Office Action Summary

This is the first Office Action for application number 10/663,107 License Plate Holding Bracket and the Holding Structure thereof, filed on 9/16/03. Claims 1-21 are pending. This application claims priority to Japan 2002-270020, 2002-270040, 2002-270044, 2002-270109, 2002-270116 all dated 9/17/02.

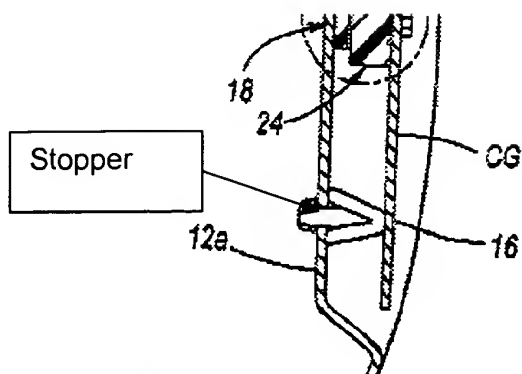
Smith discloses applicant's basic inventive concept including wherein the end side of the fixing member and the plate holding member are connected and both have a plane shape, and a stopper member (See Drawing Below, Fig. 6).

Smith does not teach wherein the stopper member resides on the plate holding member and is brought into contact with the rear bumper of a vehicle when the tailgate is horizontal and the license plate is almost erect with respect to the tailgate and contacts the tailgate and the gate side fixing member when the license plate is parallel to the tailgate and wherein the tailgate has a cavity for receiving the stopper.
